DRB FILE: #18-0246
REQUEST FOR MODIFICATION TO DRB FILE: #16-0073
802 W DILIDO RESIDENCE

DRB FINAL SUBMITTAL
APRIL 6, 2018

802 W. DILIDO DRIVE

REQUEST FOR MODIFICATION TO
DRB FILE: #16-0073, TO RAISE
GRADE IN SIDE COURTYARDS
+1'-1" ABOVE ADJ. GRADE

SOUTHCOURTYARD(PROPOSED)

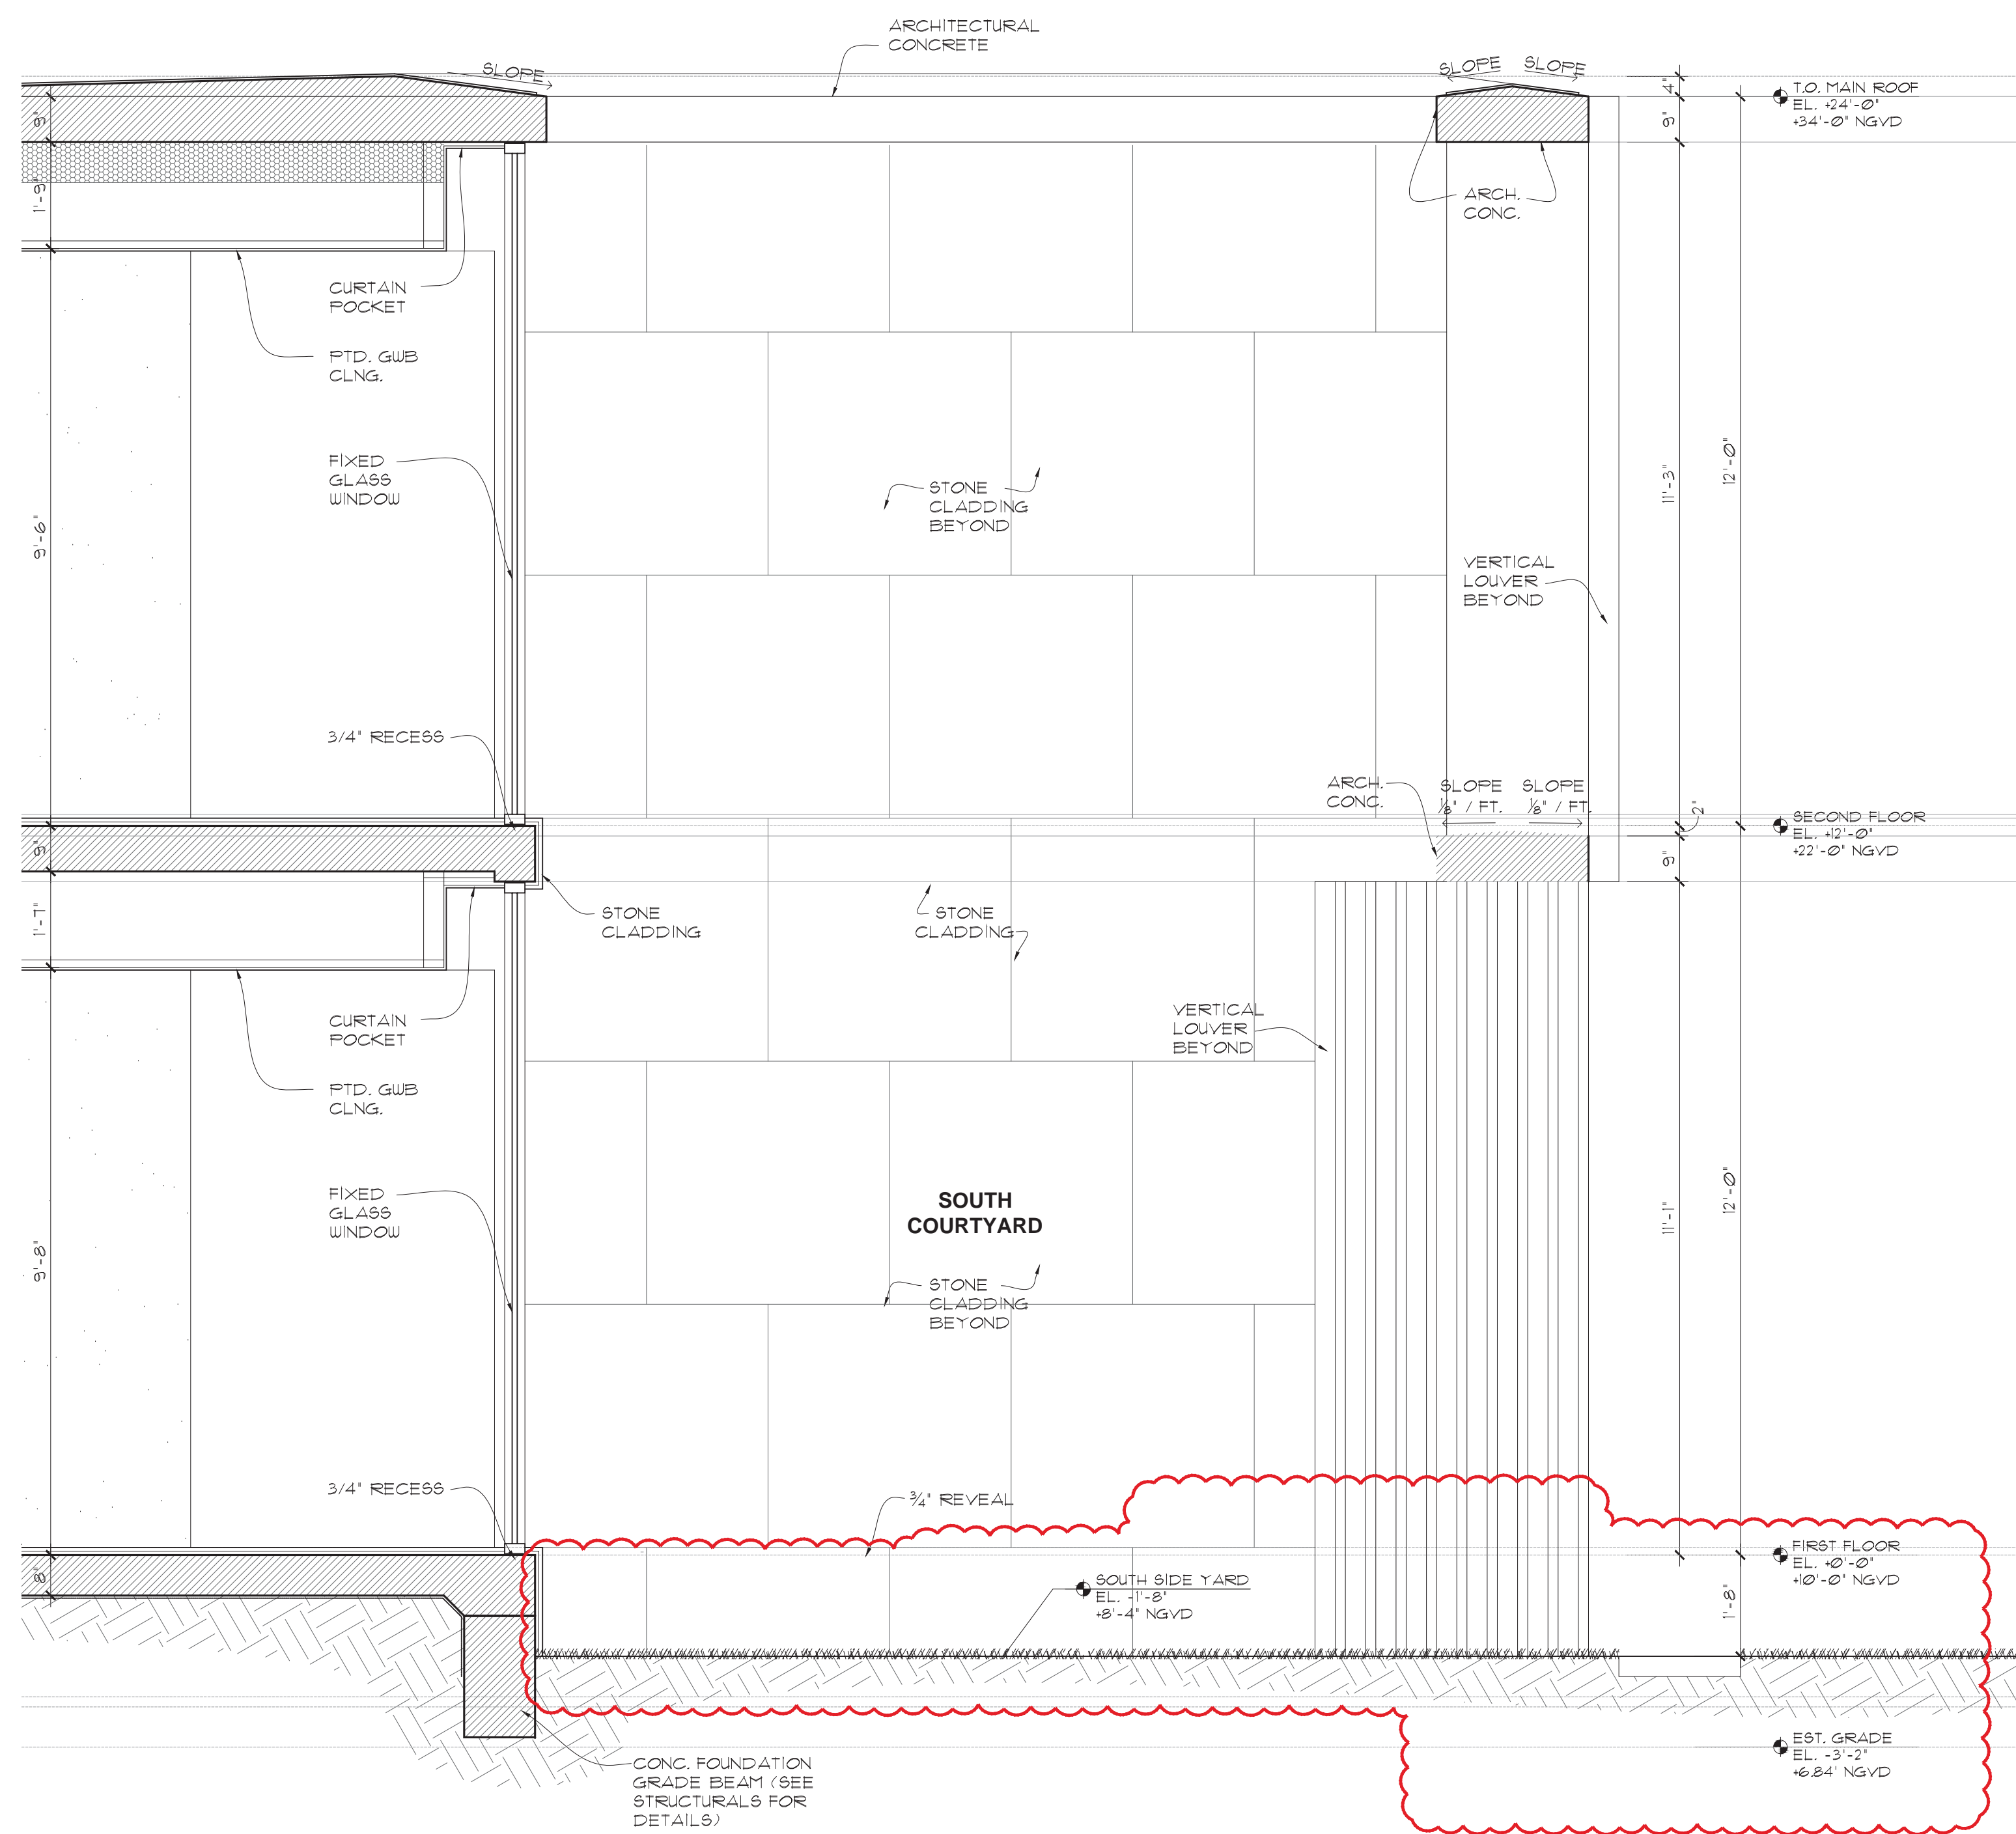
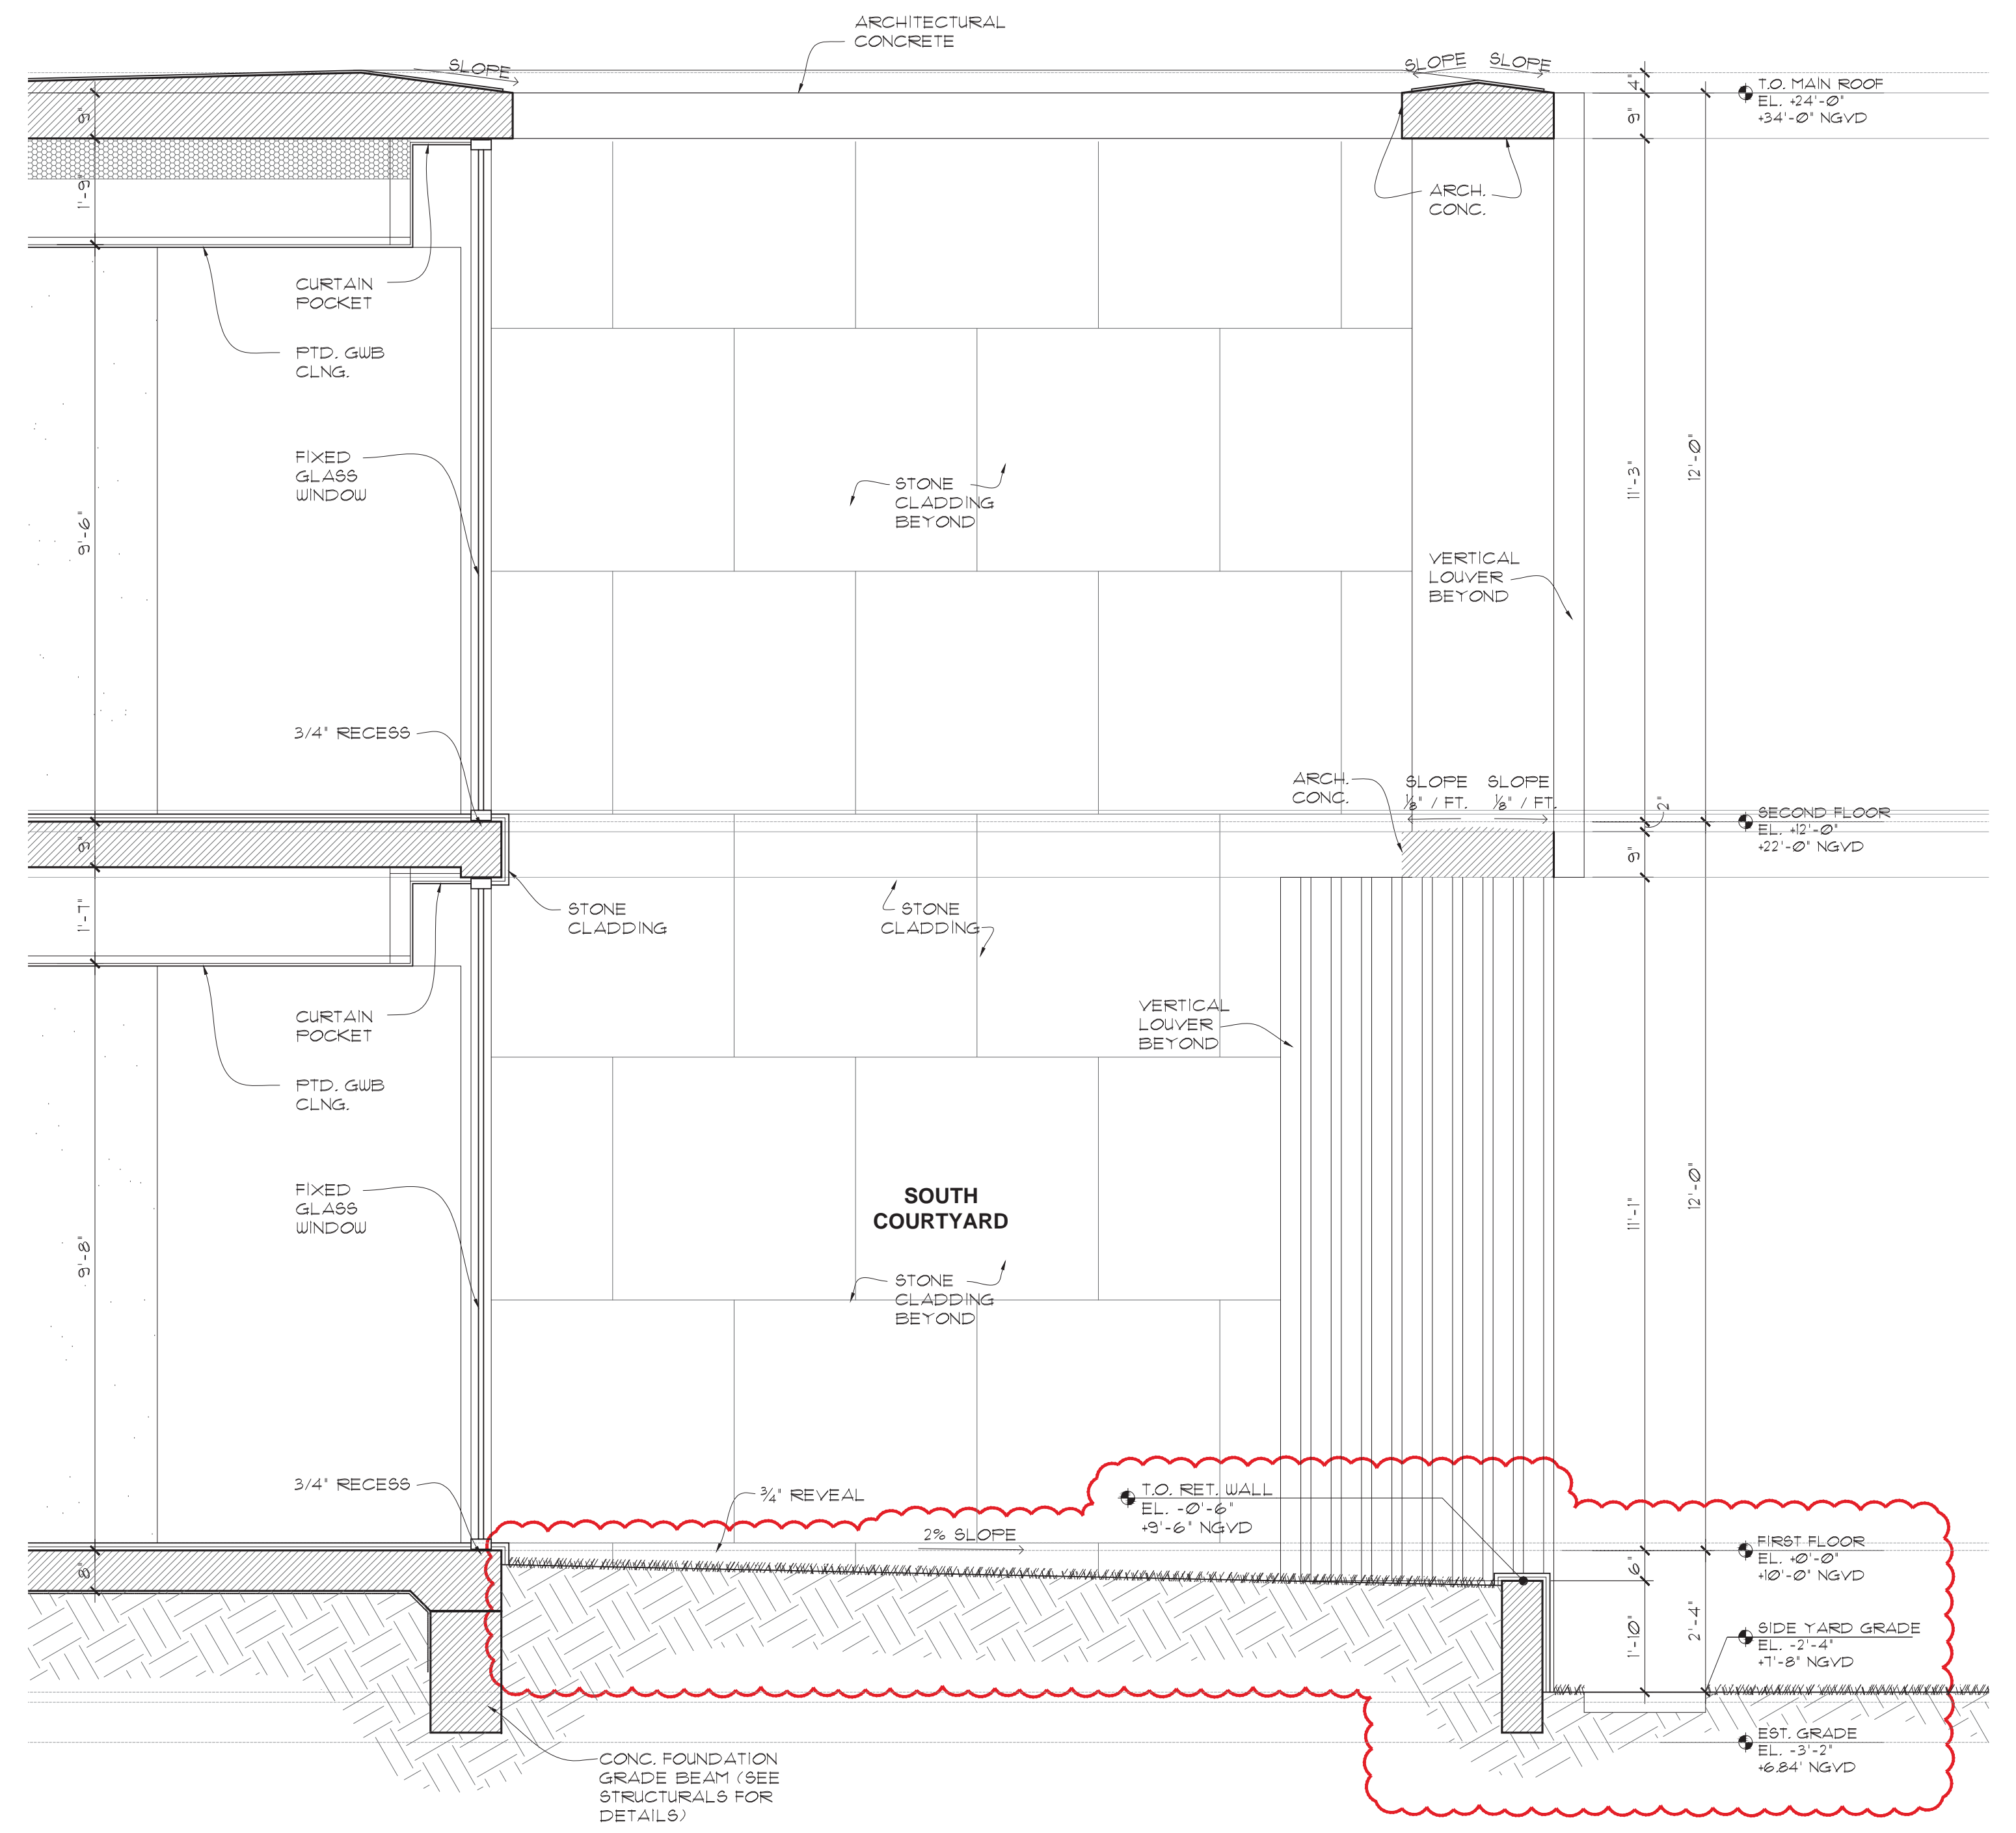
REQUEST FOR MODIFICATION TO
RAISE SIDE COURTYARDS +1'-1"
ABOVE ADJ. GRADE
